**CALIFORNIA GEOLOGICAL SURVEY  
FAULT EVALUATION REPORT FER 253  
SUPPLEMENT NO. 1**

**THE HOLLYWOOD FAULT  
in the Hollywood 7.5' Quadrangle  
Los Angeles County, California**

by  
Janis L. Hernandez  
Engineering Geologist  
November 5, 2014

**Figure 3** – Study site locality S1-1 indicated in blue shaded area. Boring transect shown as dark blue patterned line. Previous study sites included in the initial FER shown in light green.

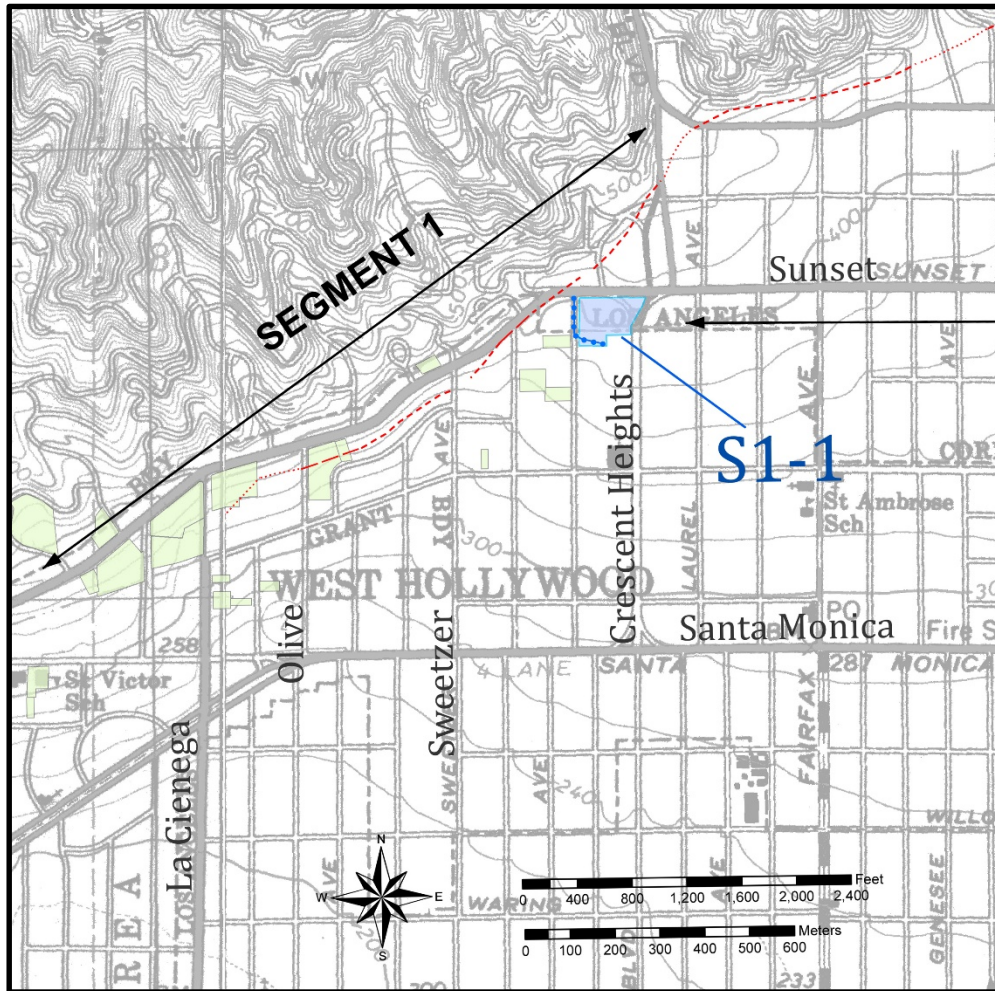
Golder Associates, Inc. (2014a, b) prepared a Surface Fault Rupture Hazard Assessment and Geotechnical Exploration study for a residential and commercial development located on the southwest corner of Sunset Boulevard and Crescent Heights (locality S1-1) as shown on Figure 3. Golder's site evaluation included a CPT transect and hollow stem auger boreholes along the western and southern site boundaries. They interpreted this transect to show continuous alluvial stratigraphy across the site. They reported silts and gravelly sands deposited less than 7 thousand years ago (ka) to depths of about 40 feet. Lower deposits ranged in age from 9 ka to 13 ka at depths of about 60 to 80 feet. They concluded the site has not had major disruption from Holocene faulting.

***The data presented by Golder Associates are consistent with the interpretation presented in the initial FER that the Hollywood Fault lies north of this site as shown on the preliminary Alquist-Priolo Earthquake Fault Zone map.***

**Figure 4** – Index map showing new localities S2-1 and S2-2. Trench locations indicated as orange line segments. Previous studies included in original FER shaded green.

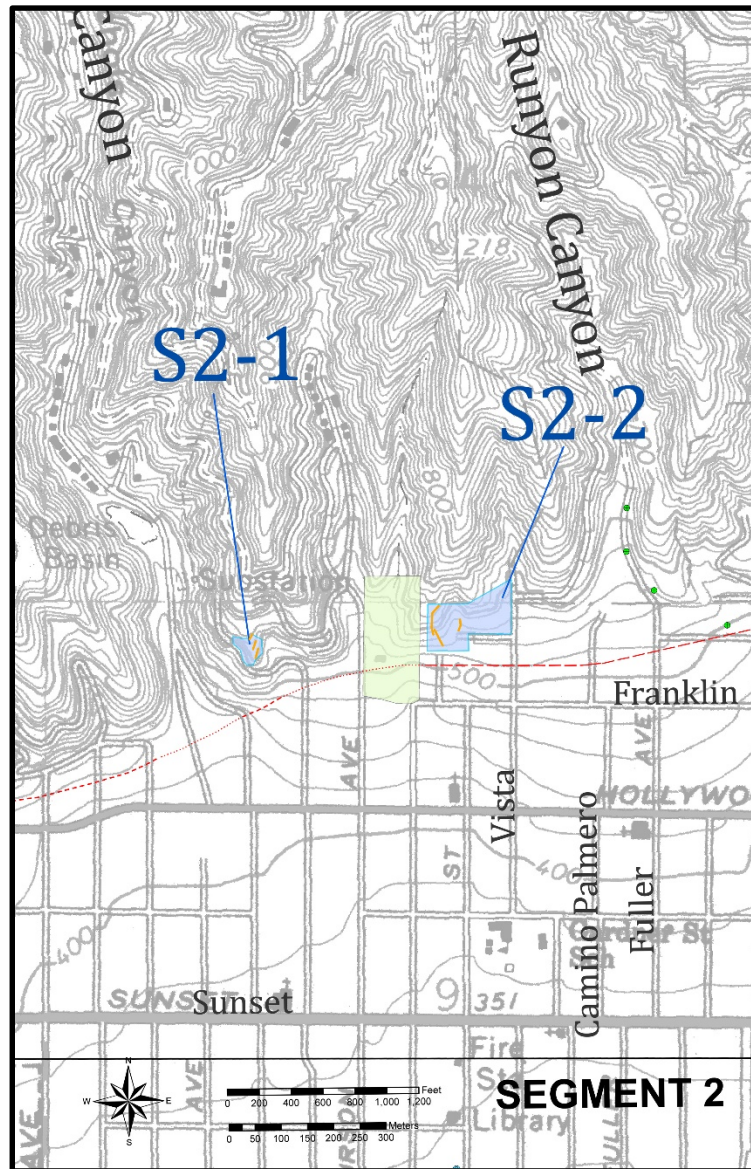
Irvine Geotechnical, Inc. (2014) performed a fault investigation for a residential project located near the base of the Santa Monica Mountains at locality S2-1 (Figure 4). Geologic mapping and shallow trenches were performed as part their study. A geologist for the City of Los Angeles observed the excavation during the study, where un-faulted quartz diorite bedrock was exposed.

Grover Hollingsworth and Associates, Inc. (2014) conducted a fault investigation for a project located along the southern edge of the Santa Monica Mountains, near Runyon Canyon at locality S2-2 (Figure 4). They excavated three fault trenches across the site and observed a thin layer of soil overlying quartz diorite bedrock. Caliche-lined faults were observed in Trenches 1 and 3, but clay gouge and slickensides were not observed in the fault zone. With field review and discussion with the City of Los Angeles geologist, Grover Hollingsworth considered these faults to be pre-Holocene.

**The data presented by Irvine Geotechnical and Grover Hollingsworth and Associates for localities S2-1 and S2-2, respectively, is consistent with the interpretation that no Holocene faults cross these sites north of the fault shown on the preliminary Alquist-Priolo Earthquake Fault Zone map.**

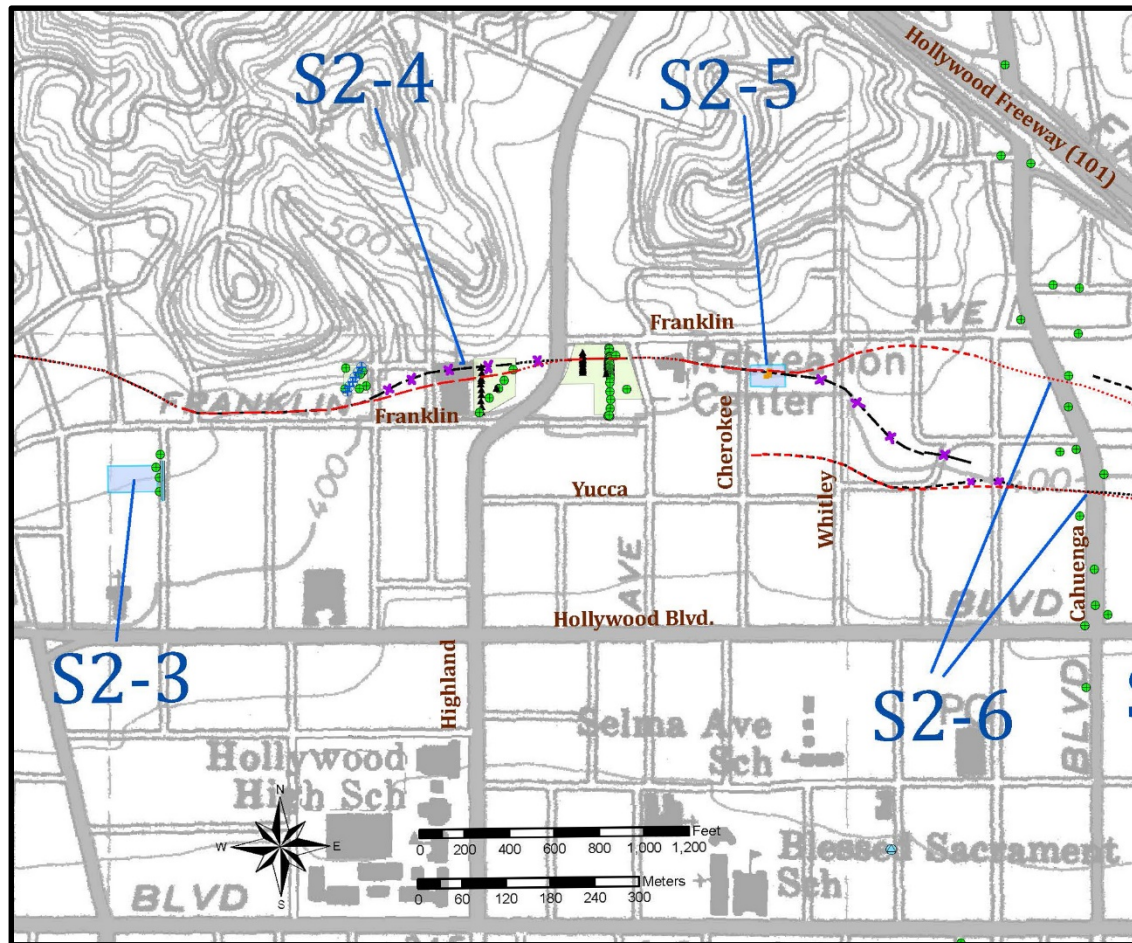
At locality S2-4 (Figure 5), (locality 12 in Hernandez and Treiman, 2014), CGS re-evaluated the fault strands at this site and compared them to the well-defined and well-constrained fault data immediately east of this location (Hernandez and Treiman, 2014), locality 13), as well as new data to the east at locality S2-5 (described below). There were several fault strands indicated in investigations at this site, and the re-assessment of the data led us to select a different strand as the dominant trace.

CGS made observations of two fault trenches at locality S2-5, south of Franklin Avenue and N. Cherokee Avenue (Figure 5). Two separate visits were made to this site by J. Treiman (CGS). The southern trench, first visited on December 31, 2013, exposed southeast dipping Topanga Formation siltstone and sandstone, with interbedded or injected volcanics. No faults were observed in this trench at this time. A northern trench, visited on January 15, 2014, revealed a broad fault zone (about 20 to 30-feet wide) within the Topanga Formation. Bedrock to the north and south of the fault zone dipped moderately to the northeast. Within the fault zone, bedding and shears had an east-west strike with steeply north to vertical dips. Shearing increased toward the northern margin of the zone which had a sharp vertical shear and a soil-filled fissure. The north margin of this soil-filled fissure appeared planar, indicating the soil was faulted, rather than just falling into a shaking-related fracture. A visit to a freshly cleaned exposure at the initial southern trench, also on January 15, showed a shallowly north-dipping shear within the bedrock to the graded surface. Soils overlying the bedrock in the northern trench appeared to be very young. To date no report has been submitted by the owner to the City of Los Angeles or CGS.

***Based on our re-evaluation of these data, we suggest a modification of the fault trace slightly to the south to project through this preferred trace, connecting the well-located fault to the east with better defined scarps to the west.***

***Our observations confirm the location of the northern strand of the Hollywood fault as presented in the initial FER.***

Figure 6 – Cross section from the Metro Red Line subway project. Portion of figure from Converse et al, 1984.

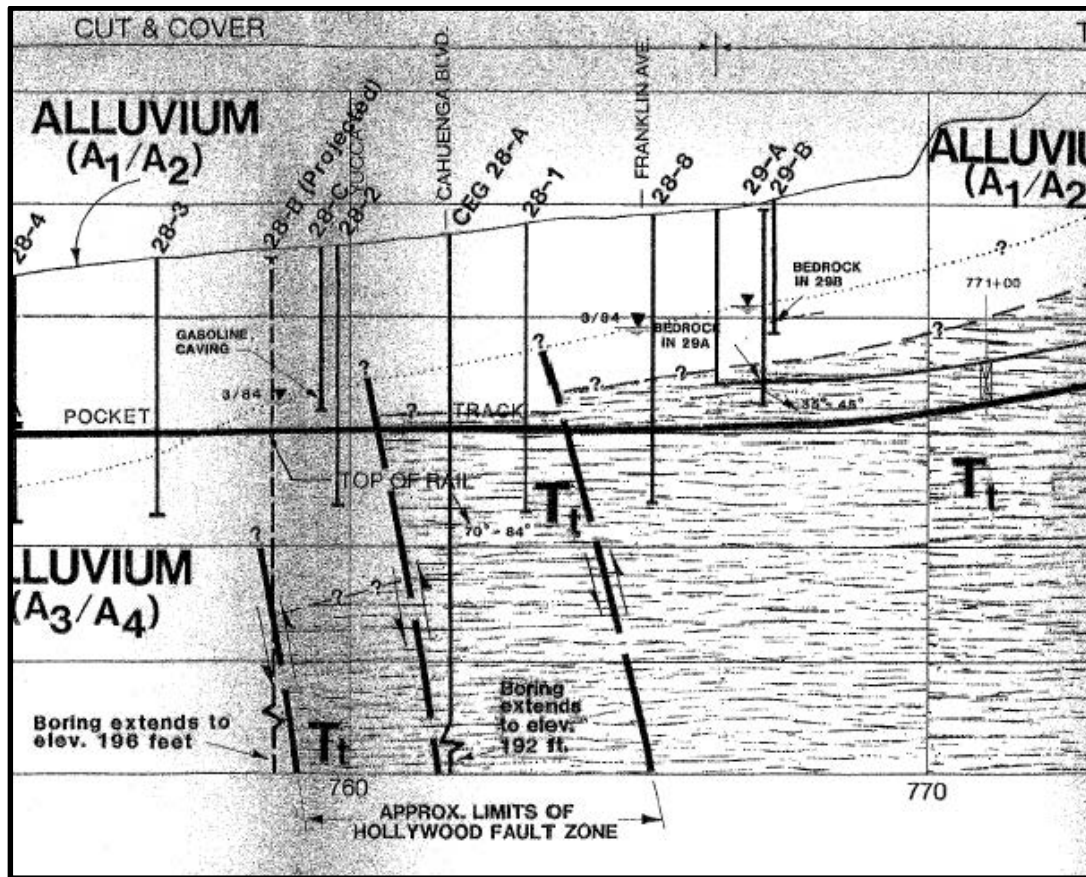
Converse Consultants, Earth Sciences Associates, Geo/Resource Consultants (1984) – locality S2-6 (Figures 5 & 7): CGS acquired a geotechnical report prepared by Converse Consultants et al (1984) for the Metro Rail Red Line Project that was not available for the initial FER (Hernandez and Treiman, 2014). The initial FER relied on data from Converse Consultants et al, (1981, 1983) and Crook and Proctor (1992), and, although the borehole data from the 1984 report were described by Crook and Proctor (1992), the original borehole logs were not in the 1981 and 1983 reports that they reference.

***The data presented by Converse Consultants et al (1984), specifically a cross section (Figure 6 herein) and boring logs, combined with observations of the fault at locality S2-5, support an eastward continuation of the northern fault trace, rather than the southeast trending orientation shown in the initial FER (that was based on Dolan et al., 1997)(Figure 7). We find the stratigraphy within the MTA boreholes reveals lateral discontinuities within the upper alluvial soils above the principal fault strands, in addition to offset bedrock as illustrated in the cross-section (Figure 6). The Converse Consultants data also supports the location of the southern trace of the fault where it crosses Cahuenga Boulevard as shown on the preliminary Alquist-Priolo Earthquake Fault Zone map. Additionally, the cross section shows a third fault that projects toward***

*the ground surface at Yucca Street, roughly between the northern and southern strands (Figure 6). Due to uncertainty as to how the various strands of this complex fault zone connect to the east and west we are only depicting the northern and southern fault traces on the Official Zone map.*

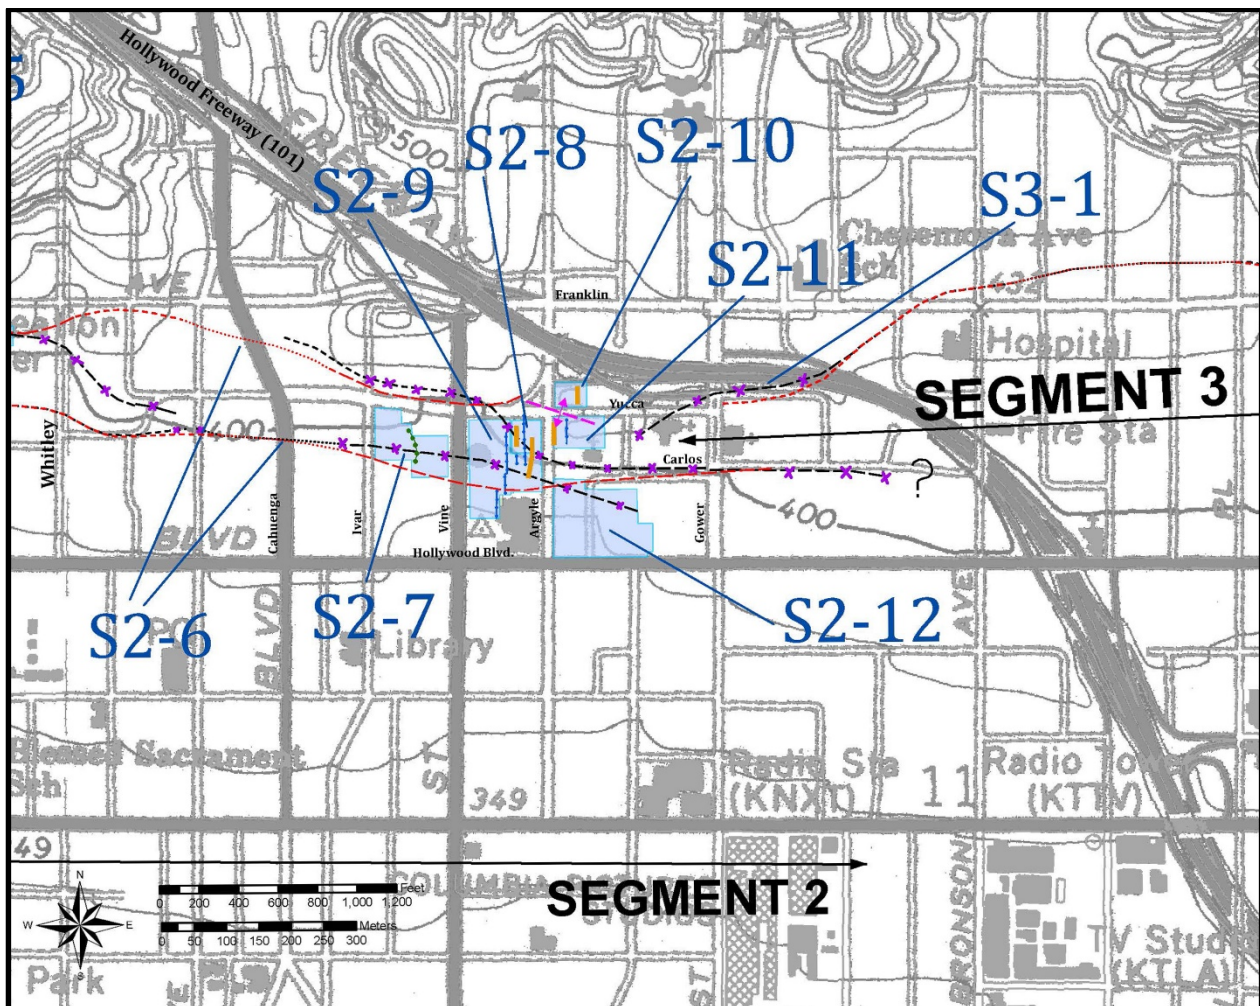
A comment was submitted by Mr. David Waite of Cox Castle Nicholson, LLP on April 8, 2014 to the SMGB (Comment # 10, Table 1), with reference to localities S2-7 and S2-9 (Figure 7) and included a request to extend the public comment period. He referenced ongoing studies in the vicinity of Yucca Street and Argyle Avenue, and requested that this information be considered prior to issuance of the final map. Mr. Waite specifically mentions the Hollywood Millennium project, and a fault study for this project that was performed by Langan Engineering (2012). He also states that conclusions from this site-specific data were not relied upon by CGS in preparation of the fault map. Further, he concludes that the lack of evidence of a fault traversing the Millennium project does not represent a “sufficiently active, and well-defined fault.” They suggest that the map should “simply delineate supportable fault zones in which individual properties would undertake subsurface investigations, as it is fault zones which signal to localities and other constituencies that additional investigation is required.” Mr. Waite also states that additional subsurface data will be submitted to the City of Los Angeles and the State Geologist in the coming weeks and months so it could be considered in preparation of the final map.

CGS was invited to most of the sites referred to by Mr. Waite, where we performed limited review of trenches in the Yucca and Argyle area. Regarding our initial review of data and preparation of the initial FER, data from the Langan Engineering report for the Hollywood Millennium project was considered. However, our analysis of the subsurface correlation between borings and review of the C14 data arrived at different conclusions. Our review of the Langan (2012b) borings showed a major discontinuity between borings B-1 and B-5. This subsurface discontinuity is the boundary between gently south-dipping alluvial fan deposits to the north and fine-grained clayey deposits to the south. We interpret that this abrupt contrast in lithology indicates the presence of a fault. Regarding the statement that additional data will be submitted for this project, CGS has received no additional data for the site west of Vine Street at the time of this supplemental report, and only limited data for the site east of Vine Street.

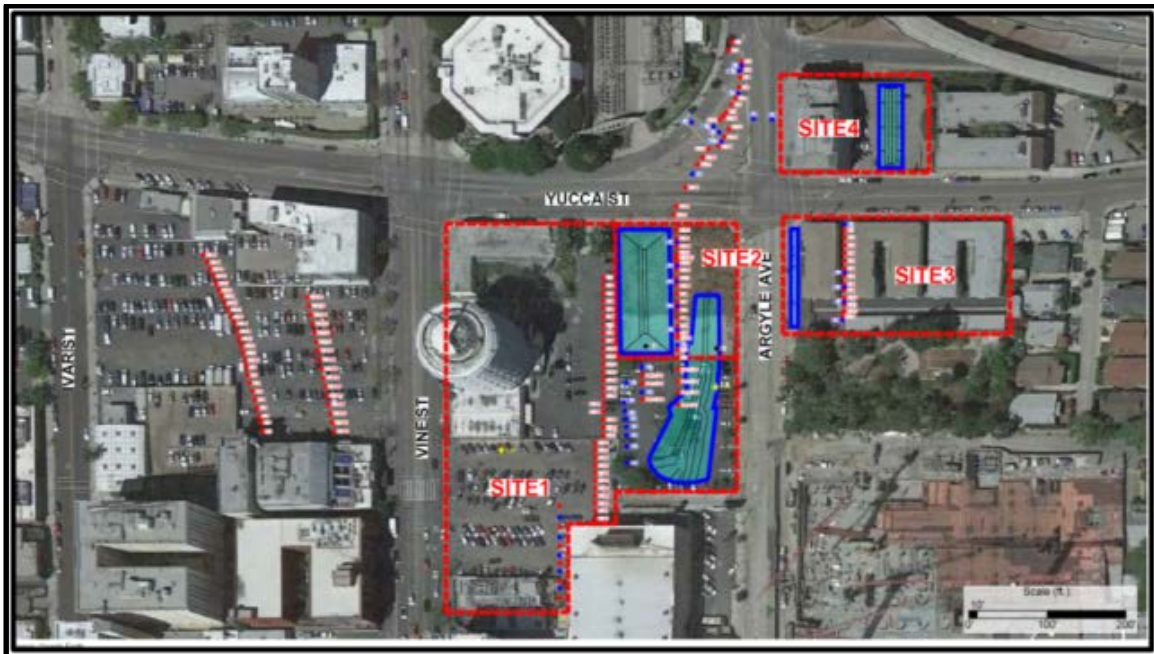
A comment was submitted by Mr. Michael Reader of Group Delta Consultants, Inc. (GDC) on March 13, 2014 to the SMGB for locality S2-8 (GDC Site 2, Figure 8). Mr. Reader stated that although there are mapped locations where the Hollywood Fault is somewhat well-defined, in the area between Cahuenga Boulevard and Gower Street the Hollywood Fault is concealed by alluvial fans, and that no data in this area have located the active trace. He also reported that the geologic community agrees the active trace of the Hollywood Fault lies “somewhere” in this area. However, he questioned the delineation of the zone for this area, with such sparse available data.

A fault study, conducted by Group Delta Consultants, Inc. (2014a) was submitted to the SMGB on May 6, 2014 for locality S2-8 (GDC Site 2, Figure 8). This study included core boring and CPT transects and an approximate 100-foot long, 30 foot deep trench on the western portion of the site. GDC reported that they found no evidence for faulting in the Holocene units on this site. The study also reported age estimates of weathered soil horizons at two locations within the trench, prepared by Dr. Roy Shlemon, and included test results from two charcoal samples submitted for C14 dating.

GDC reported the site is underlain by fluvial channel deposits, locally named the Argyle Channel, which they estimate to be Holocene. Underlying the Argyle Channel deposits, they report a clayey sand layer. The contact between the lower clayey sand and the overlying Argyle Channel sands is reported to be an erosional unconformity. The lower clayey sand is reported to be at least 12 to 15 ka, based on relative soil pedogenic development exposed in the trench. Age estimates by GDC are based on soil development described by Dr. Roy Shlemon, in Appendix B of their report, and correlation of the unconformity with ice age sea-level low stand at during marine isotope stage 2. Radiocarbon dates reported for the Argyle Channel deposits were about ~4.3 ka, and ~41 ka at about 14 feet, and 18 feet below the ground surface (bgs), respectively. GDC prefers the soil-stratigraphic and paleo-environmental age estimates for the Argyle Channel deposits and does not use the radiocarbon dates.

A second Fault Activity Report was submitted by GDC for locality S2-8, dated September 3, 2014 (Group Delta, 2014b). This investigation consisted of additional CPT and core borings from adjacent sites in the vicinity, and an additional trench located on the eastern portion of the site that also extended south into GDC Site 1 (locality S2-9). During this second investigation, GDC reported a bedding plane fault underlies the site, where they concluded this fault is overlain by a buried paleosol “indicative of about 30 ka of weathering.” This trench was excavated in response to comments by the City of Los Angeles noting that faulted Pleistocene sediments were found directly across the street to the east (GDC, Site 3; locality S2-11). Within this eastern trench at locality S2-8, Argyle Channel deposits were exposed, underlain by mudflow deposits (previously referred to by GDC as the clayey sand or “basal clay” unit). Underlying the mudflow deposits they reported well-consolidated older alluvial debris flow deposits that are dipping gently to steeply to the south. C14 dates near the base of the Argyle Channel deposits were reported at ~4.1 to 4.3 ka. (Group Delta, 2014a, 2014b). The soil ages within the trench were derived from soil profile descriptions from R. Shlemon. GDC concluded that folding and related slip observed in their trench occurred prior to deposition of the mudflows, capped by a remnant buried paleosol of about 30 ka, and are overlain by the unbroken, estimated ~12 ka Argyle Channel deposits.

***The initial FER (Hernandez and Treiman, 2014) provides strong evidence that the fault is well-defined to the west of the Yucca Street/Argyle Avenue area. Reasonable projection of the Hollywood Fault in this area was inferred based on supportive evidence to the west, geomorphic interpretation, and limited subsurface data. There is also good evidence the fault continues to the east, suggesting that a continuous zone of faulting extends across the map. The purpose of the map is to require investigations, like those Mr. Reader refers to in the Yucca Street/Argyle Avenue area, to ensure fault rupture is not a hazard to human lives and habitable structures.***

***The data presented in the GDC report appear to be consistent with the interpretation that the Argyle Channel deposits are of Holocene age. However, multiple C14 samples GDC reported within their trenches near the base of the Argyle Channel, are only ~4.3 ka and thus the channel deposits do not represent the complete Holocene record. We consider the Argyle Channel deposits to be approximately 6 ka, based on C14 data throughout the two trenches, and related soil development. The interpretation that the underlying clayey deposit is pre-Holocene appears to be consistent with the reported data. Detailed analysis of the soil profile development was prepared by G. Seitz, of CGS, and is included in Appendix A of this supplement. This analysis includes further comments regarding the reported age classification of the Argyle Channel deposits, and underlying clayey sand unit.***

*The data presented in the GDC report regarding faulting of these deposits is also open to alternate interpretations. The trench log and correlation by GDC show that Argyle Channel deposits are unfaulted across much of the site. CGS performed a field review of the west trench on two occasions, the first was not extensive enough to verify all of the consultant's conclusions due to safety concerns, however a subsequent visit afforded the opportunity to view the clayey sand deposits and relative soil development at the base of the trench. Our review of the CPT and core boring data for GDC Site 2 finds the Argyle Channel sand unit appears to be continuously correlated between borings and CPT tests, however the underlying clayey sand unit is shown to be discontinuous across portions of the site. Our review further notes the cross sections illustrated by GDC favor the CPT correlations, where core boring data in some areas does not directly support their stratigraphic interpretation.*

*CGS viewed several stages of the eastern trench investigation that was placed to potentially expose faulting that may project onto GDC Sites 1 and 2 from GDC Site 3 (to the east). Faulting was observed in this east trench at approximately 80 feet from the northern trench end, placing this fault at about the same location and orientation as the trace mapped by CGS in the Preliminary EFZ map. Further observations of this fault during June and July, 2014, revealed that age of faulting appeared to be constrained by an overlying, unfaulted mudflow deposit and paleosol, estimated to be about 30 ka by R. Shlemon (GDC, 2014c). The soil structure within the soil that overlies the fault does not exhibit rotation of pedogenic faces and appears undisturbed by movement along this particular fault trace. Two older faults, below and cut by this fault, were also observed in the tilted fan deposits but were not logged by GDC.*

*Based on this new trench data, as well as other data, we have relocated the northern fault strand to project along Yucca Street toward the north. The southern fault strand is also modified in this area based on data from locality S2-9 (GDC Site 1), described below.*
